# 42 HONEYSUCKLE DRIVE COTTAGE CREEK PRECINCT NEWCASTLE

STATE SIGNIFICANT DEVELOPMENT (SSD-10378)  
DEVELOPMENT MODIFICATION 2

ARCHITECTURAL DESIGN STATEMENT

NOVEMBER 2021

# 7.1

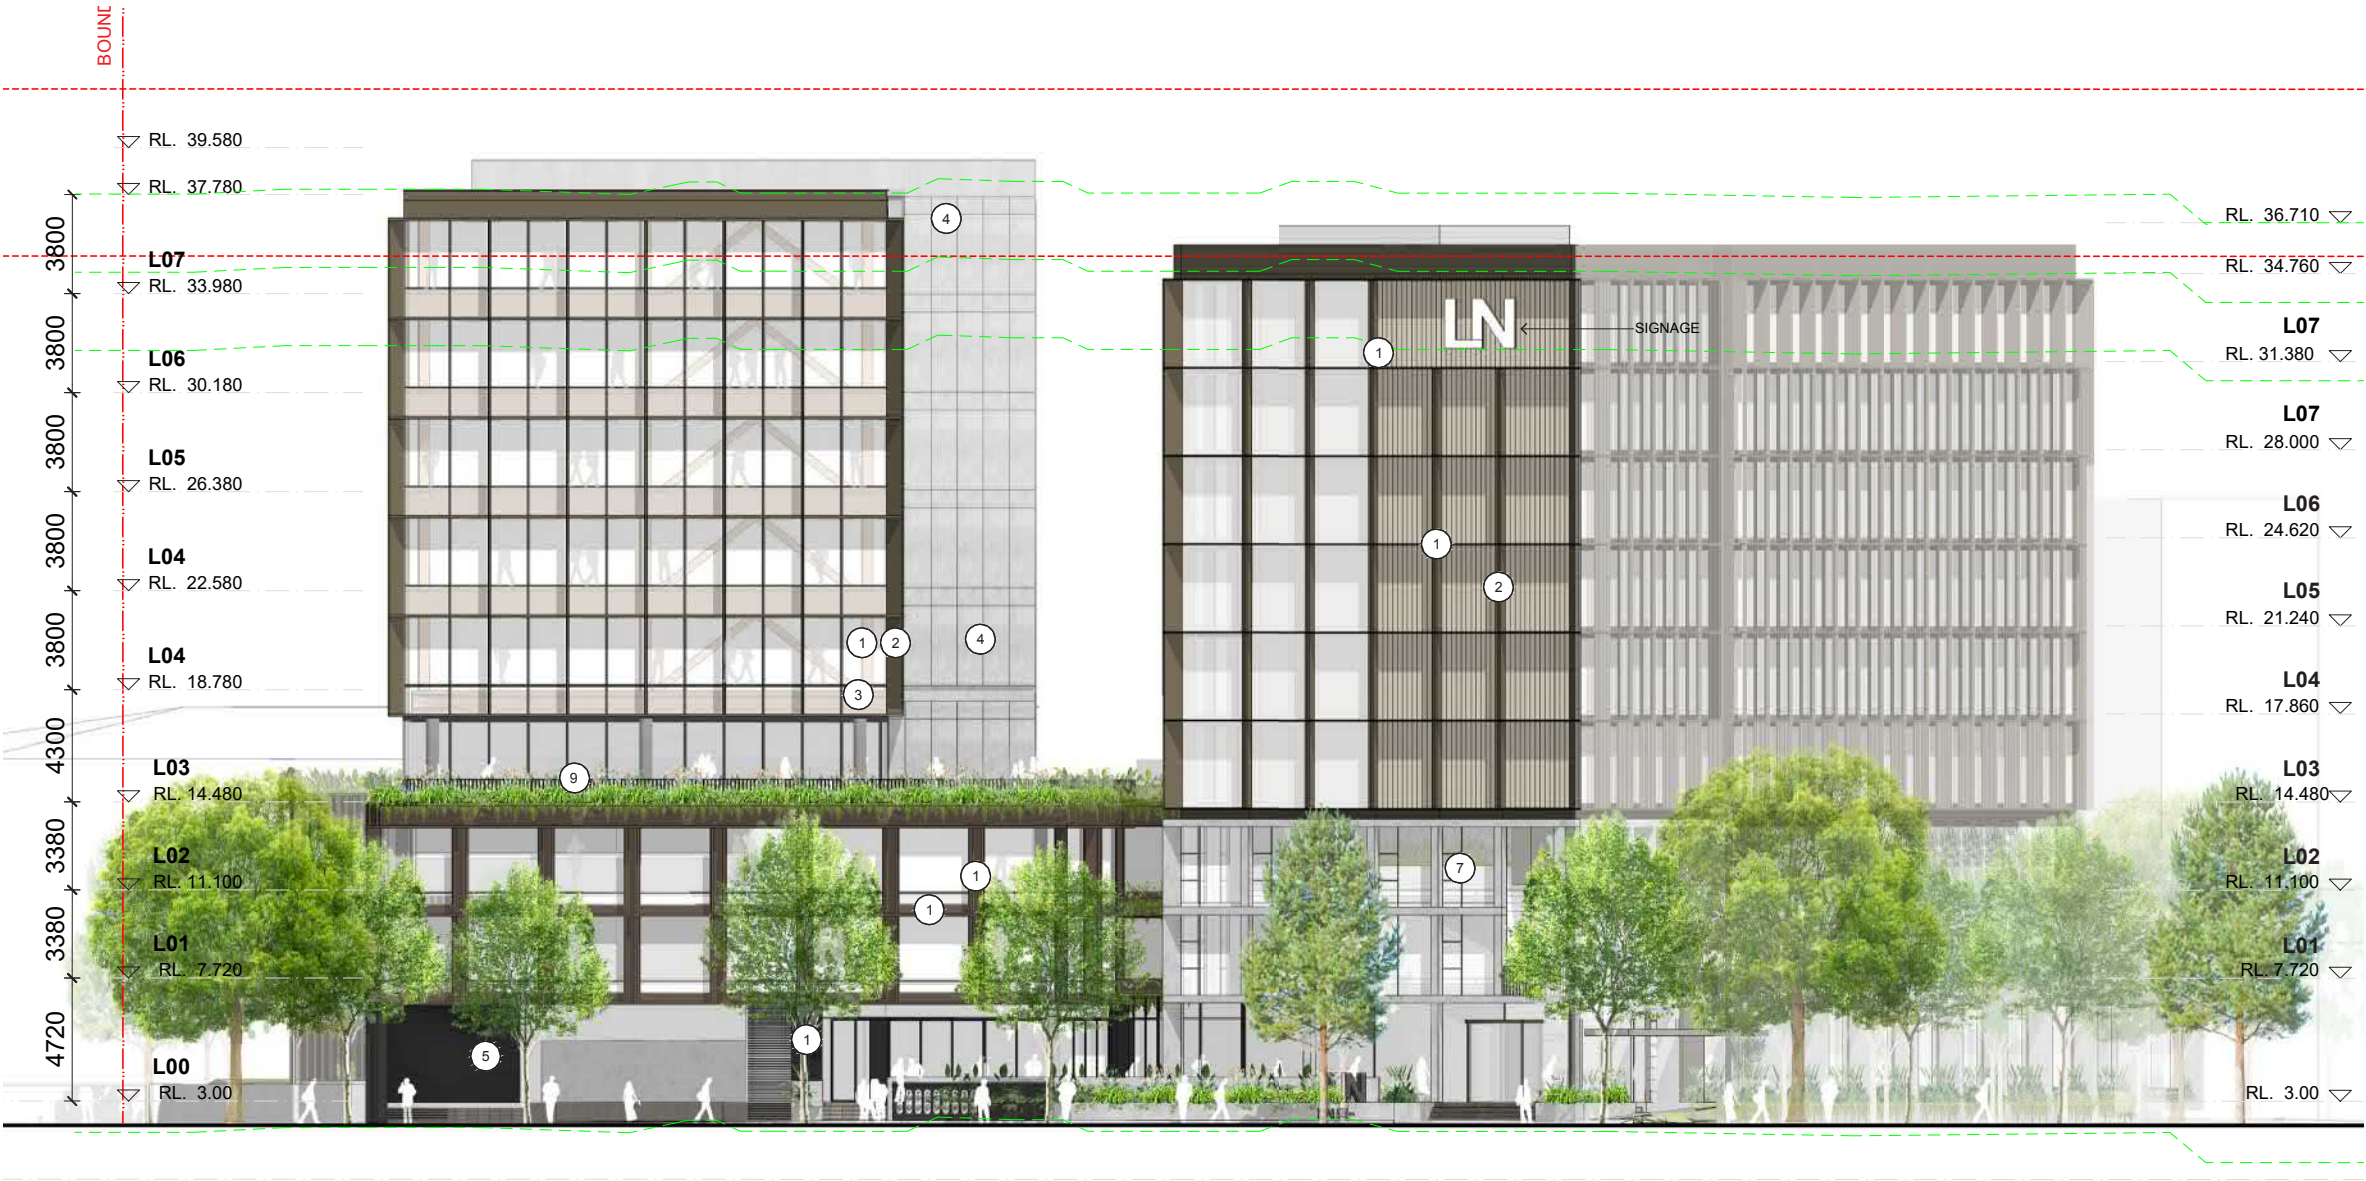
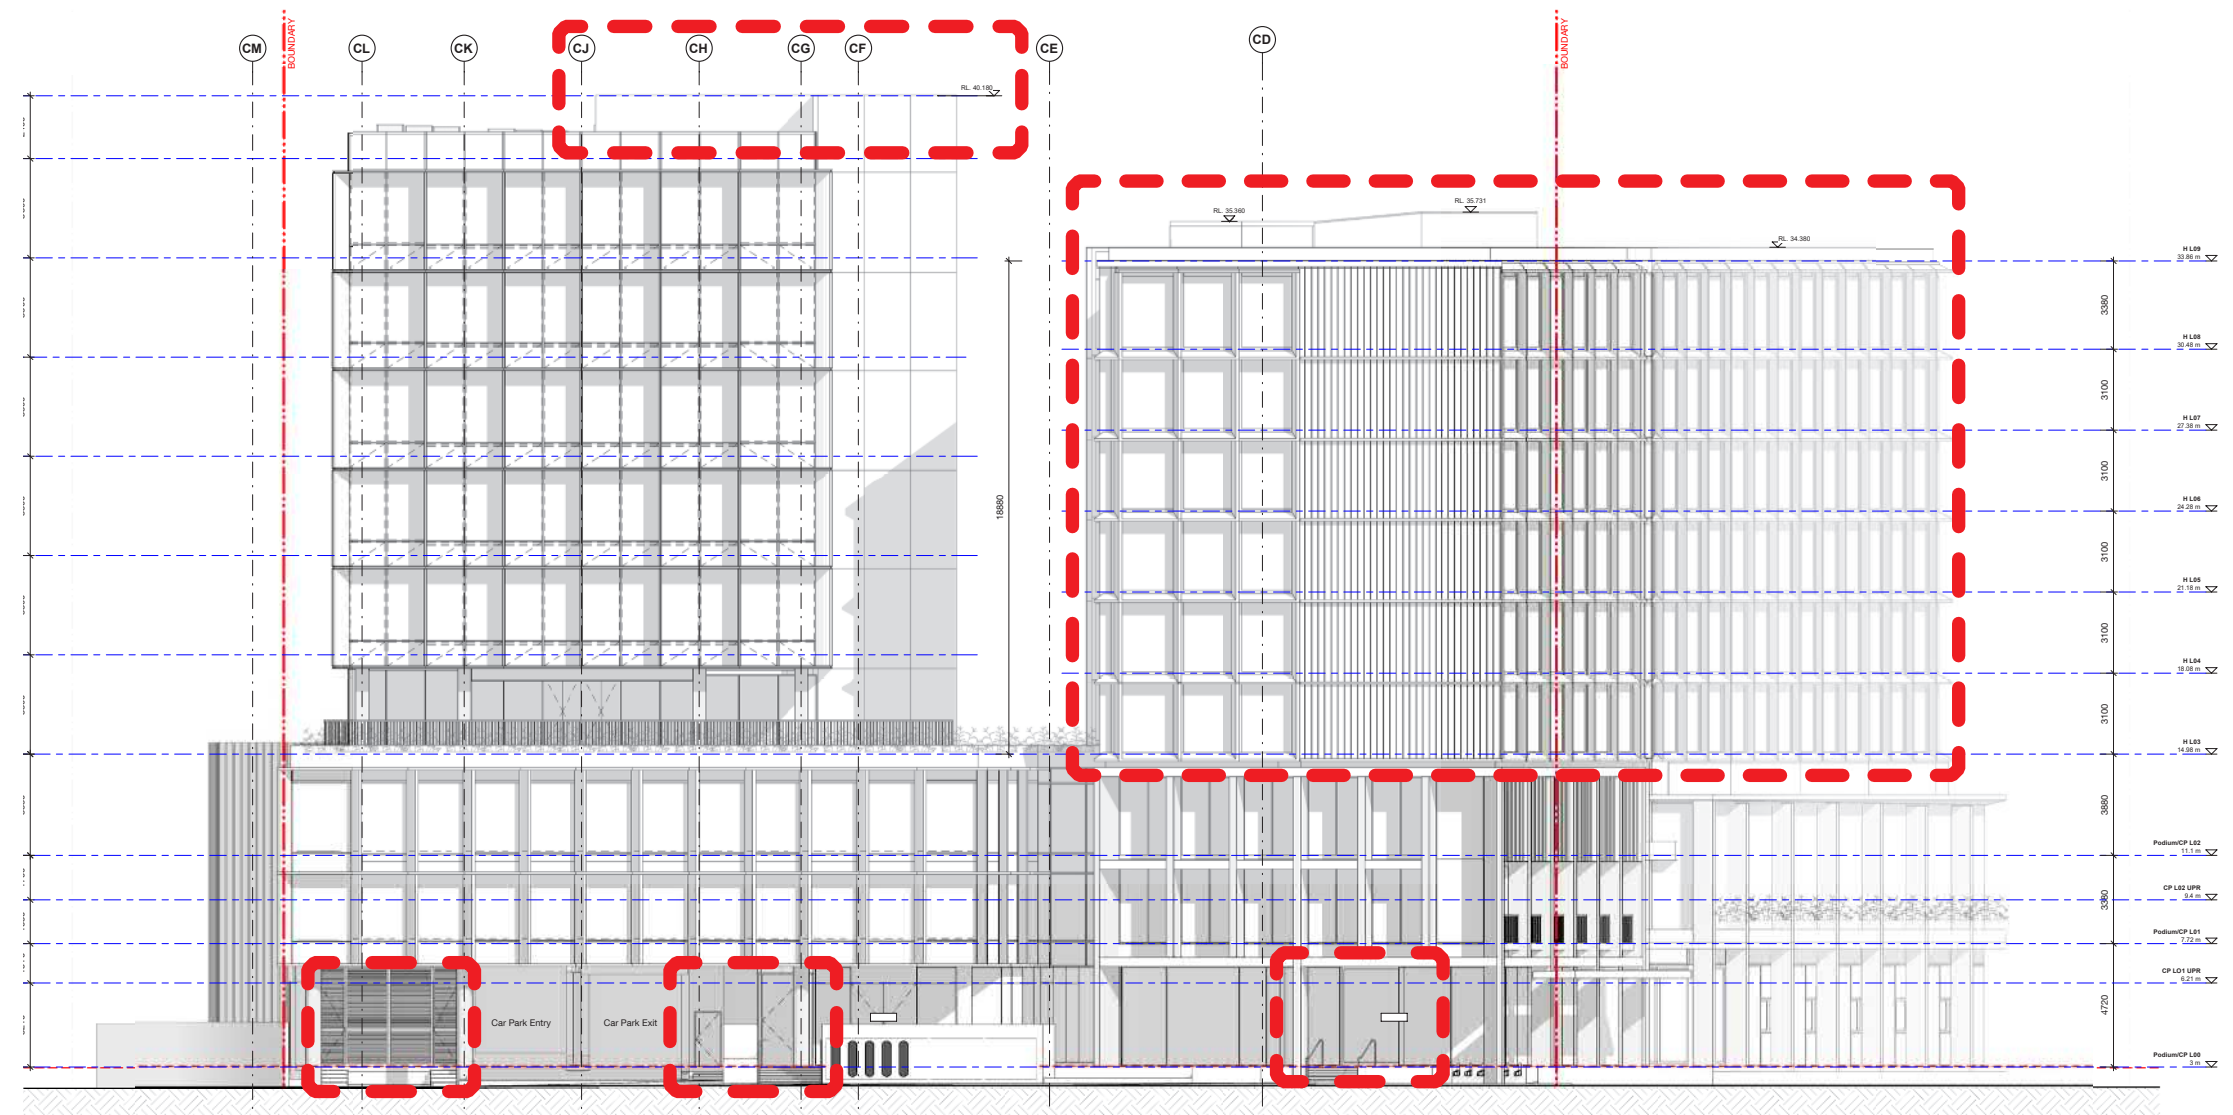
- 1 / Substation location shifted to align with structure over
- 2 / Commercial lobby and associated external access stairs shifted
- 3 / Hotel entry and associated external access stairs shifted
- 4 / Hotel slab to slab levels reduced from 3380mm down to 3100mm. This has resulted in an overall hotel building height reduction..
- 5 / Commercial tower height increased by 600mm to allow for additional plant height

# 8.1

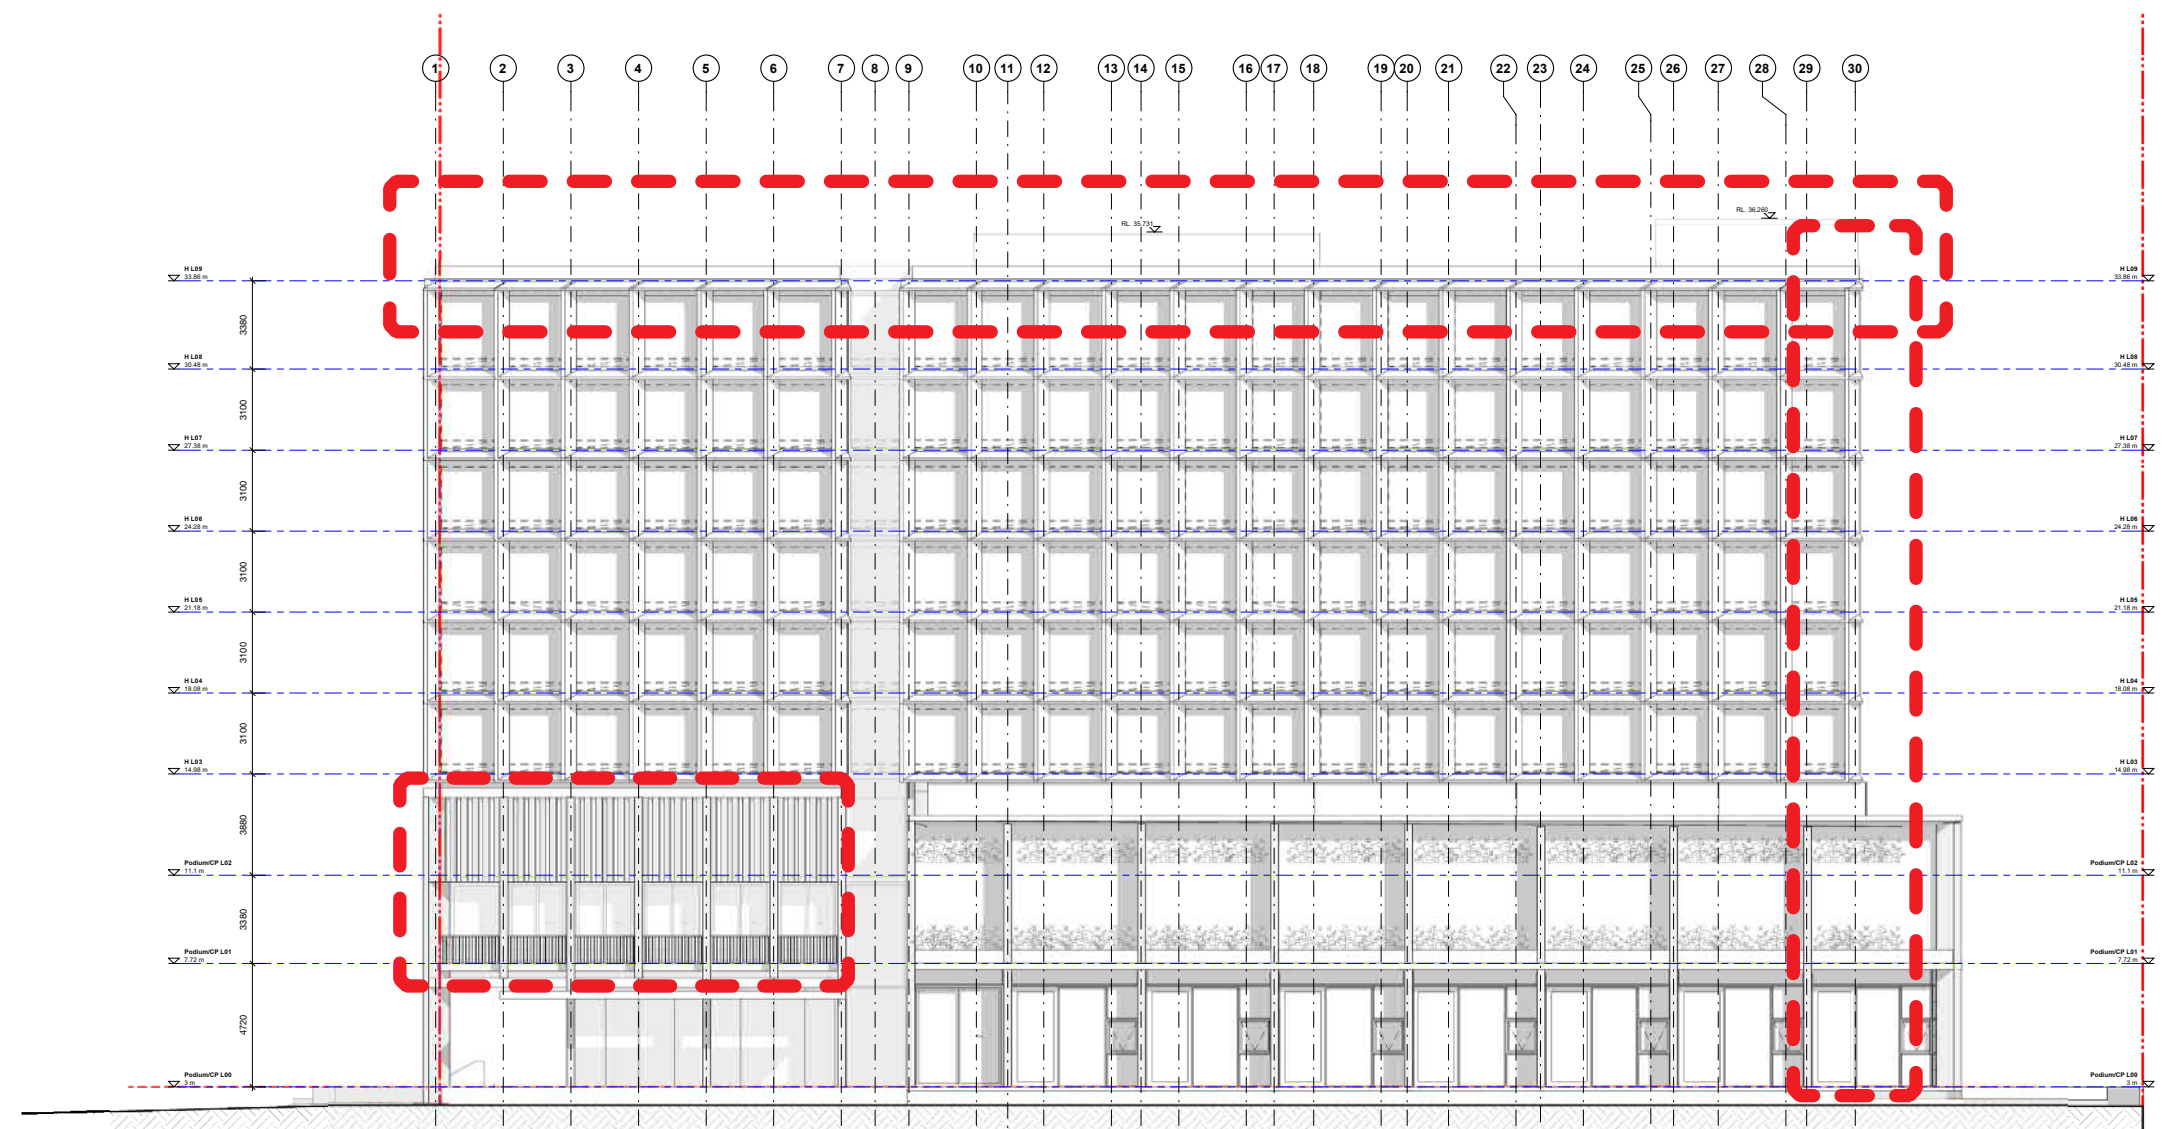
1 / Hotel slab to slab levels reduced from 3380mm down to 3100mm. This has resulted in an overall hotel building height reduction.

2 / L01 and L02 North/west corner amended. External terrace omitted and sunshading added to level L02

3 / Hotel south end of building has been reduce in length by 1 hotel room width.

4 / Arbor structure has been pulled back at the south boundary.
